Review of the Sustained Yield Plan / Habitat Conservation Plan for the properties of The Pacific Lumber Company, Scotia Pacific Holding Company, and Salmon Creek Corporation

Dr. Leslie M. Reid
 USDA Forest Service Pacific Southwest Research Station
 Redwood Sciences Laboratory
 1700 Bayview Drive, Arcata CA 95521

Review of the Sustained Yield Plan / Habitat Conservation Plan for the properties of The Pacific Lumber Company, Scotia Pacific Holding Company, and Salmon Creek Corporation

Figure 1. Expected volumes of woody debris input for various riparian management strategies as a function of distance from Class I and Class II streams in Site Class 2 redwood forests.

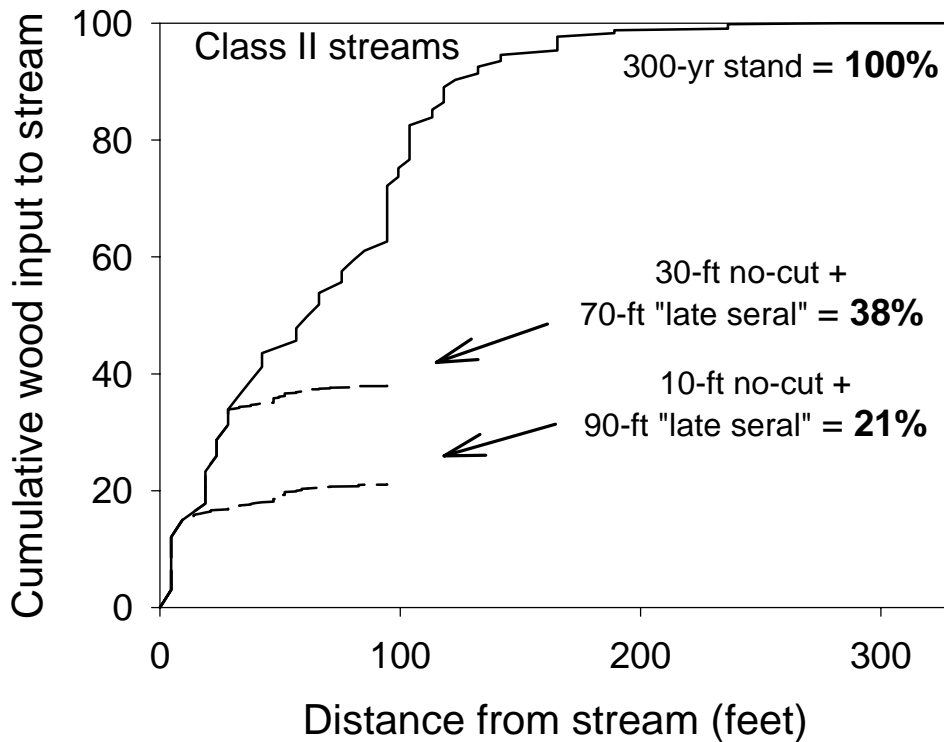
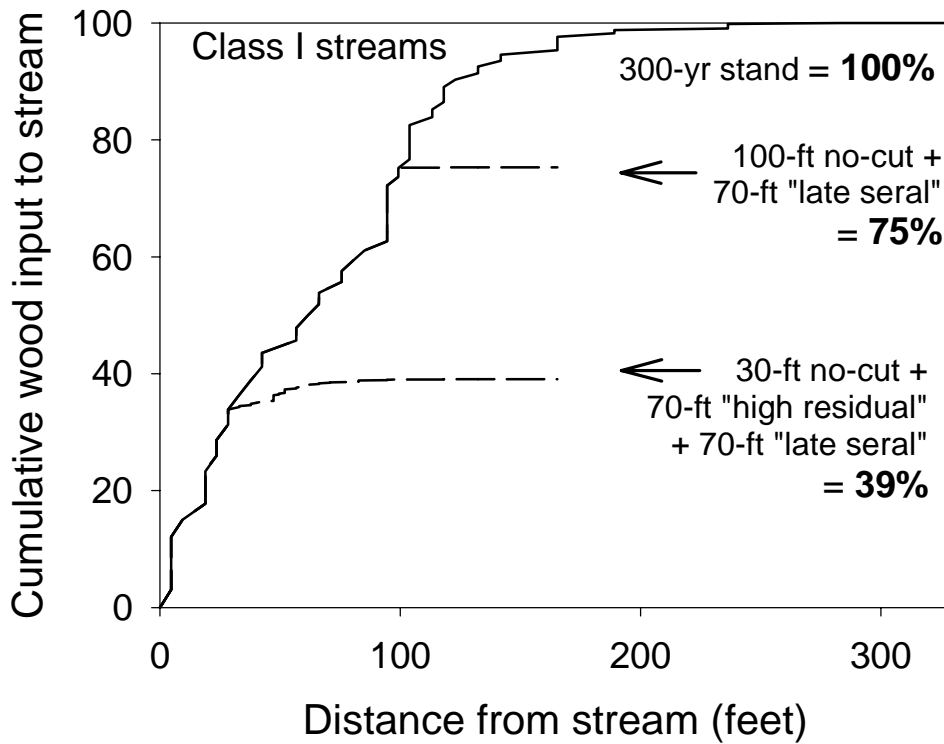
The influence of SYP/HCP prescriptions on the woody debris regime was evaluated by calculating the difference in woody debris input rates expected from a 300-year-old redwood stand on Site Class 2 land and those expected for Class I and Class II channels under the proposed plan (Figure 1). The distribution of wood inputs as a function of distance from a stream was available for second-growth redwood forests in Mendocino County, California (Reid and Hilton 1998; note that this information was available in time for inclusion in the SYP/HCP, as shown by the SYP/HCP's inclusion of other information from the conference at which these data were presented—see the reference to “Lisle 1998, in press” in IV-H-7 ph.1, for example). This distribution pattern was then applied to the stand densities and characteristics described by the SYP/HCP for riparian protection zones, those expected for 300-year stands on the basis of information provided by Lindquist and Palley (1963), and those prescribed by California State Assembly Bill 1986. Inputs were also evaluated according to the distribution of debris sizes expected (Figure 2) by assuming that tree trunks are conical. Calculation methods are described in Appendix 1.

Results of the calculations indicate that the SYP/HCP prescriptions will provide only 21% of the volume of wood characteristic of unmanaged conditions in Class II streams, and that most of the pieces contributed will be small. Under these conditions, debris-flow mobility is expected to increase over that for forested conditions, and the effectiveness of the channels in moderating downstream flood peaks will be reduced. Class I streams will receive approximately 39% of the characteristic volume of woody debris. Here, too, opportunities to halt debris flows and to store flood waters will be reduced in comparison to pre-management conditions and to existing conditions. Winter refuge habitat for salmonids will also be reduced. In addition, the increased incidence of debris flows caused by the permanent depletion of wood in Class III streams will result in aggradation of downstream channels, burying woody debris in the larger channels and thus decreasing its effectiveness.

Figure 3. Expected volumes of woody debris input for various riparian management strategies as a function of distance from Class I and Class II streams in Site Class 1 redwood forests.

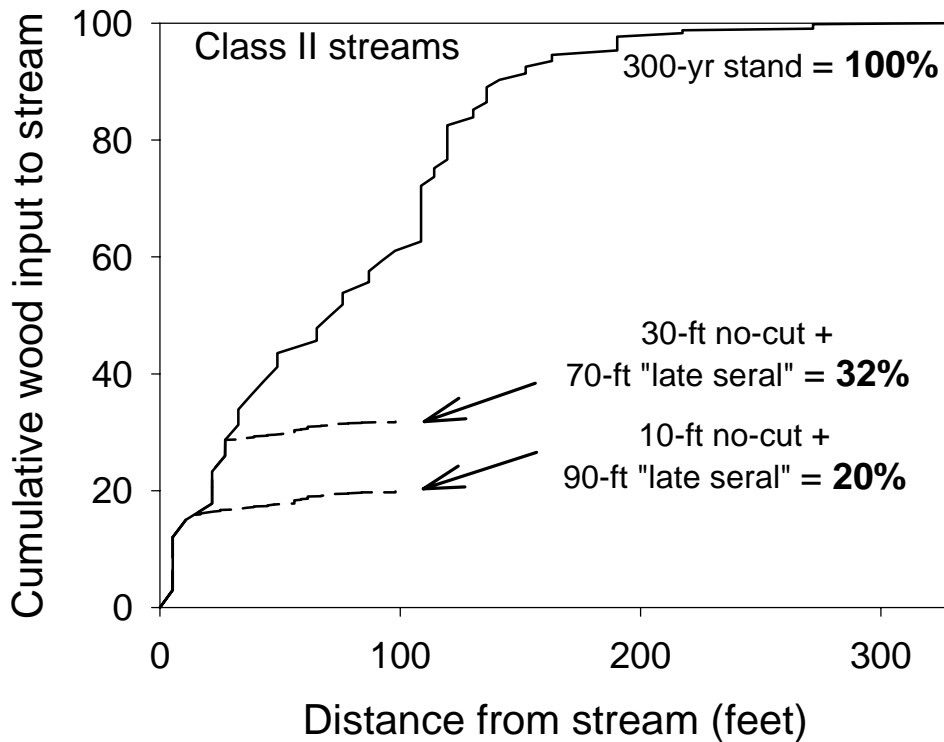
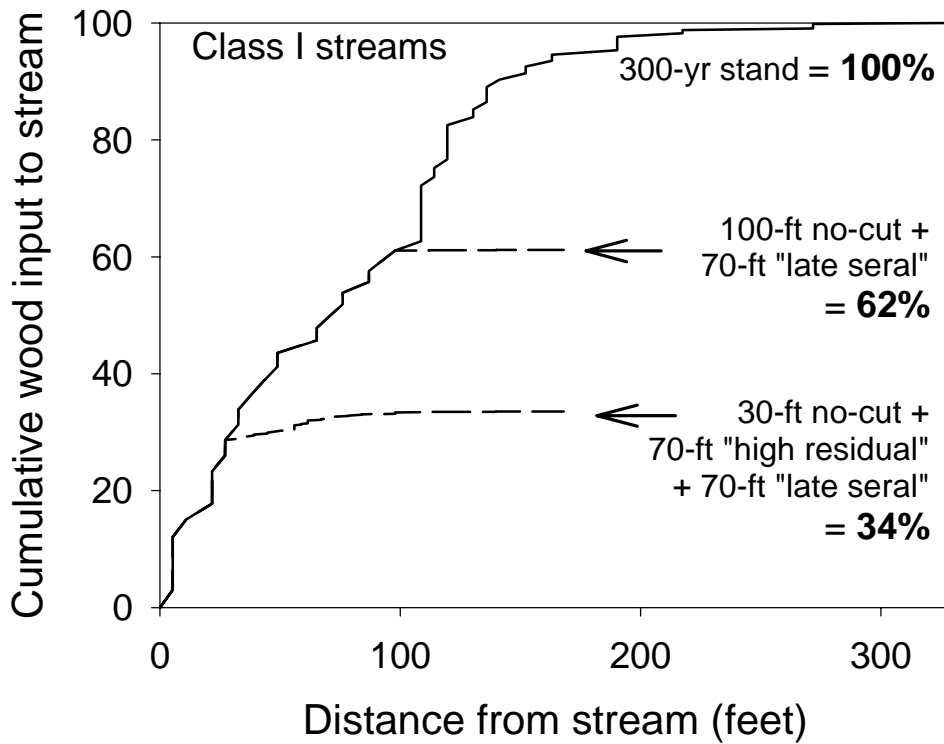
The above calculations were made for streams adjacent to lands of Site Class 2. However, examination of Map 6 in volume V of the SYP/HCP indicates that many portions of the stream systems that are most important to anadromous salmonids are adjacent to Site Class 1 land. The calculations were thus redone for lands with a site index of 200 (see Appendix 2). On these lands, the SYP/HCP prescriptions provide only 34% and 20% of the woody debris volumes contributed under unmanaged conditions for Class I and Class II streams, respectively (Figure 3). Provisions of AB 1986 would produce 62% and 32% of the necessary wood. Site Class 1 lands are generally found on riparian bottomlands, so channels adjoining Site Class 1 lands tend to be larger than those of Site Class 2 lands. It is even more important that woody debris be of sufficient size to remain in place in these larger channels; small pieces are very likely to be washed away.

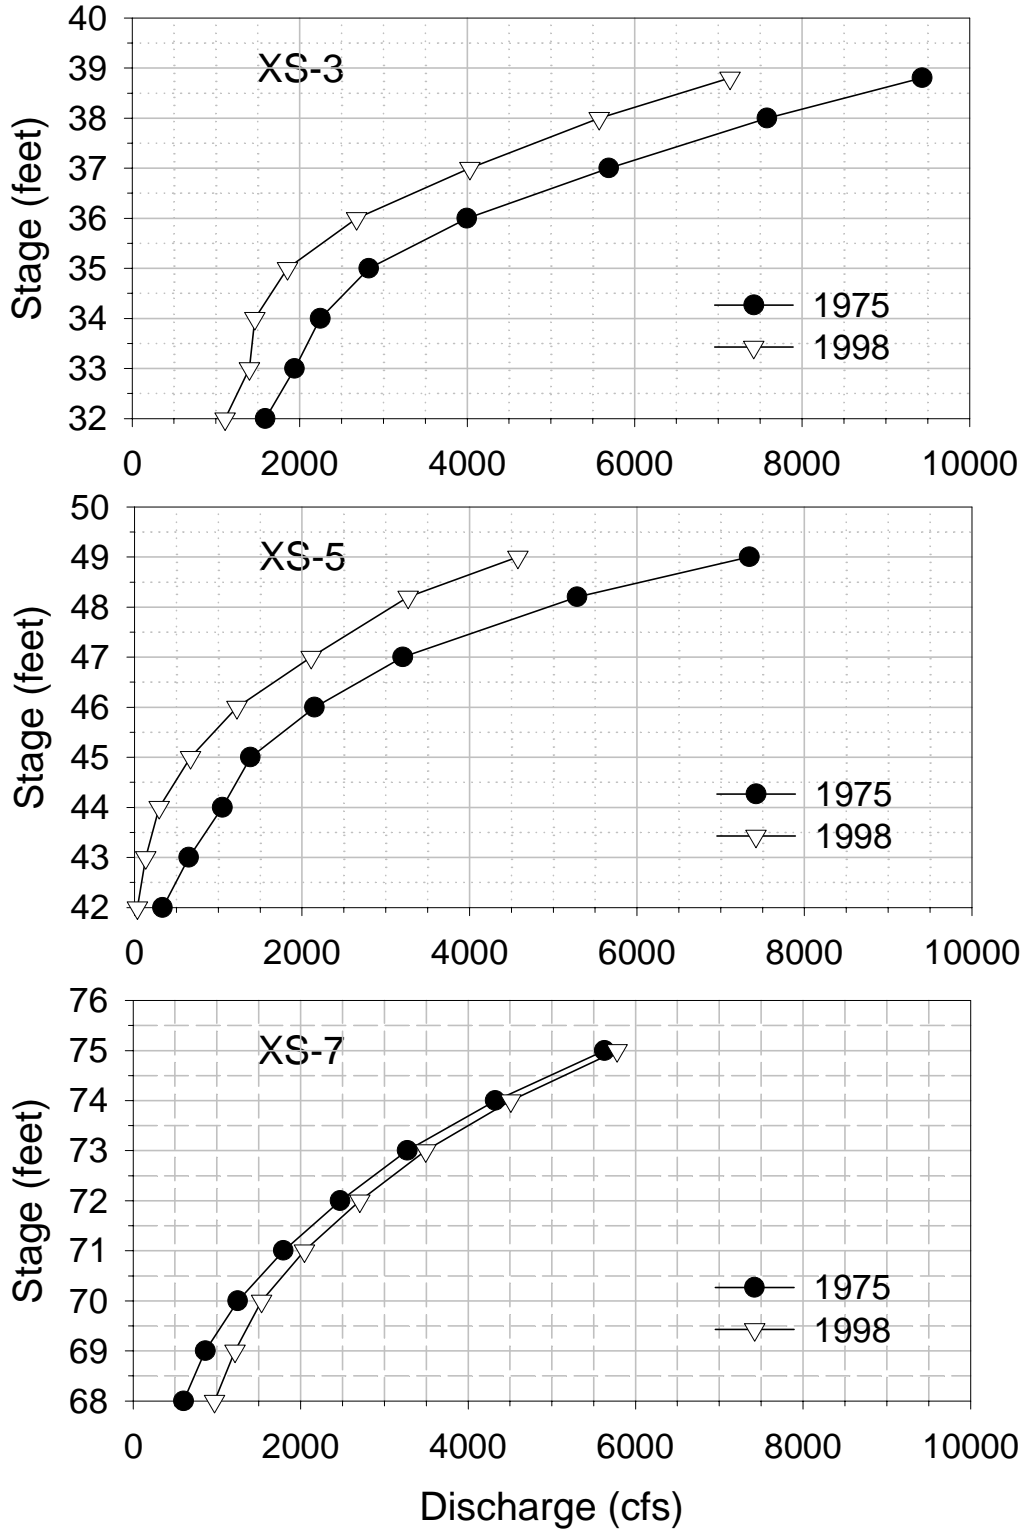
Stage can now be plotted as a function of discharge to provide an indication of the extent to which flood severity has been altered as a result of channel changes occurring between 1975 and 1998 (Figure 9 of review). The shift in the discharge-stage relationships for the two downstream cross sections indicates that flood heights for a given discharge have increased approximately 0.8 feet at XS-3 and 1.0 feet at XS-5. At both sites, the USACE (1975) report indicates that the stage of the 50-year-recurrence-interval flood was approximately 0.8 feet lower than that of the 100-yr flood. The calculated 0.8- to 1-foot increase in flood stages due to channel aggradation is thus responsible for approximately doubling the frequency of the 100-year flood at the downstream sites. In contrast, flood stages at the upstream site are not appreciably modified.

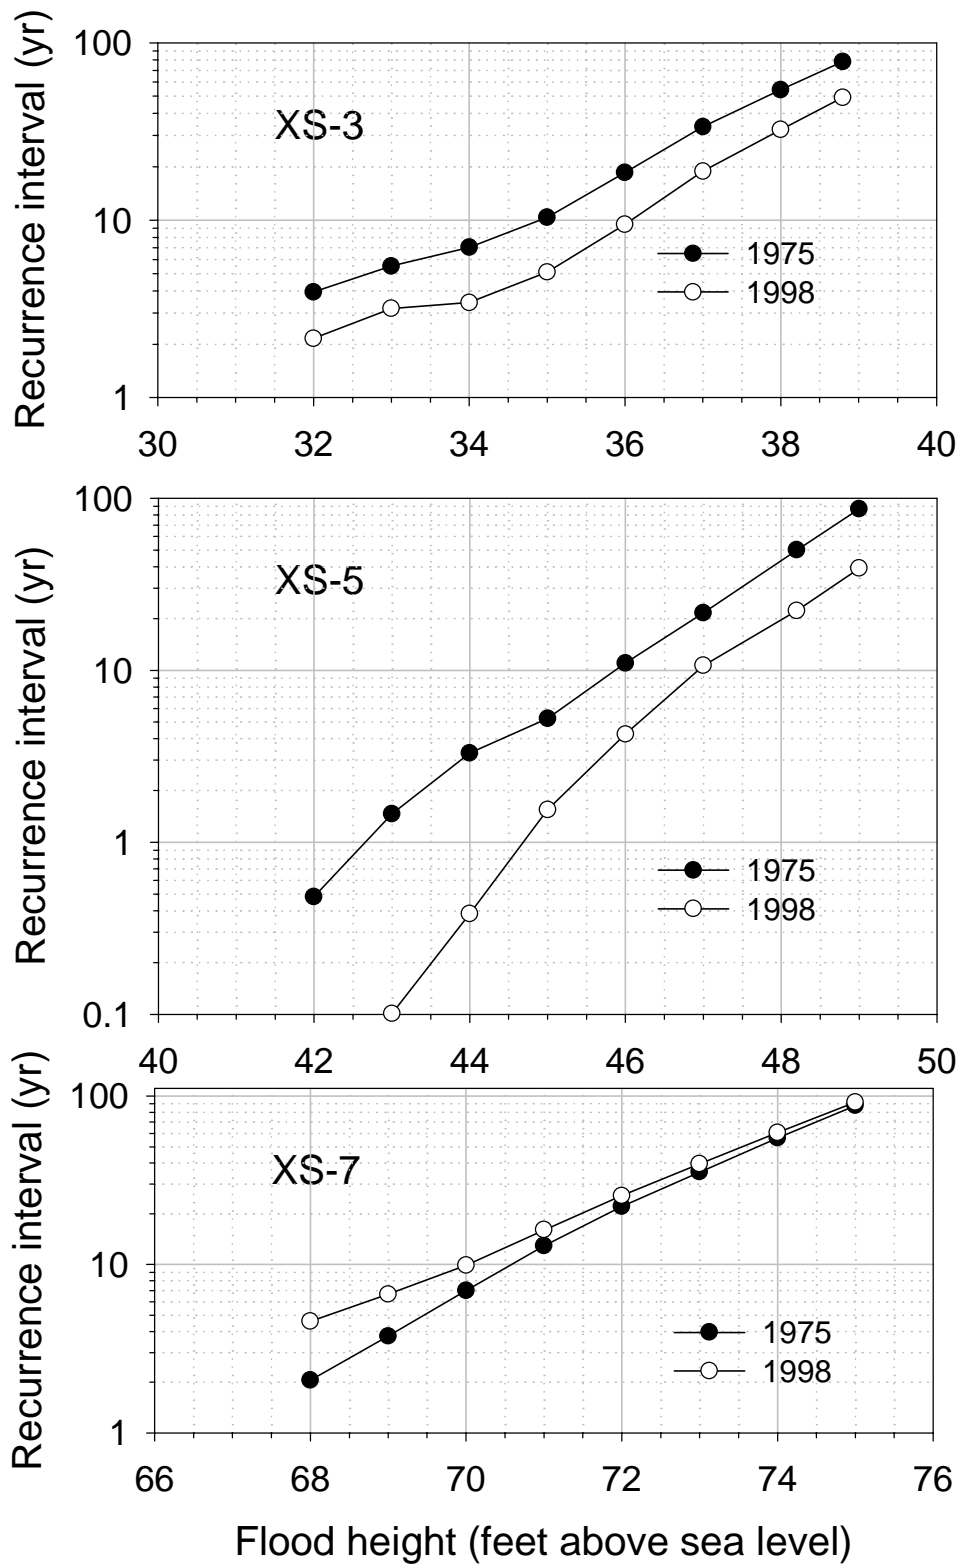
where Q_{avg} is the mean discharge at the location, 59.9 cfs at XS-3, 43.9 at XS-5, and 33.4 at XS-7. Recurrence intervals can now be plotted against stage for the 1975 and 1998 cross sections at each site (Figure 10 of review) to show the frequency with which particular stages are exceeded. Results generally show a doubling of flood frequencies at XS-3 and XS-5. In contrast, the site influenced by recently constructed dam shows decreased frequencies of exceedence at lower stages and little change during the largest floods.
